Addendum #1 for the SVS System Nox Emission Reduction System
11/08/2011

Attachment 5, Amendment 3

Refer to bid issue drawing A334A-1000-D1, Key Note #8, and related photos.

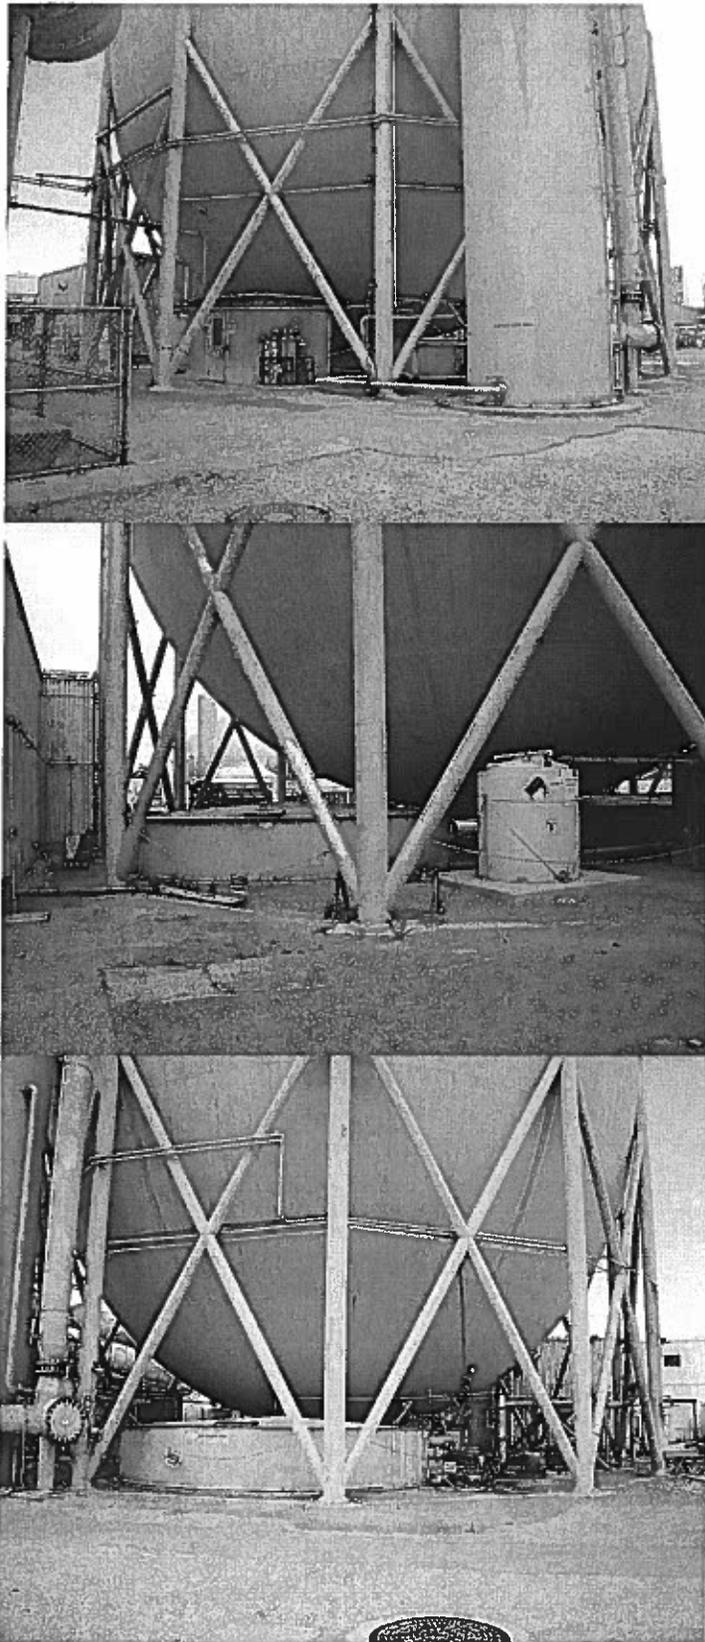
A: The vacuum sphere is identified as Sphere #6. It is a "Hortonsphere" built by Chicago Bridge & Iron Co. It's of carbon steel with a diameter of 75'-4 1/4"; shell thickness is 1- 5/16" thick; on concrete pier foundations. The exterior of the sphere is painted with lead based paint. The interior surface was painted with lead based paint, but has been largely removed due to chemical corrosion. The Contractor must collect all loose and peeling paint from metal surfaces to avoid contamination of the surrounding ground surfaces. Ground cover may be required during the demolition to collect paint debris from contaminating the ground.

B: The NOx scrubber is to be removed to its foundation. Remove the surge holding tank and the surge waste tank to the concrete foundation. Tanks are approx. 28' diameter by 4' high with bottom steel plating.

C: Remove all associated piping, valves, supports, to the concrete foundations. Remove 3 motor and pumps assemblies (P-6, 150 HP, P-7, 20 HP, P-8, 30 HP). Include cleanup of lubricants and hydraulic oils. Note that not all incident piping/devices are shown on drawing D1.
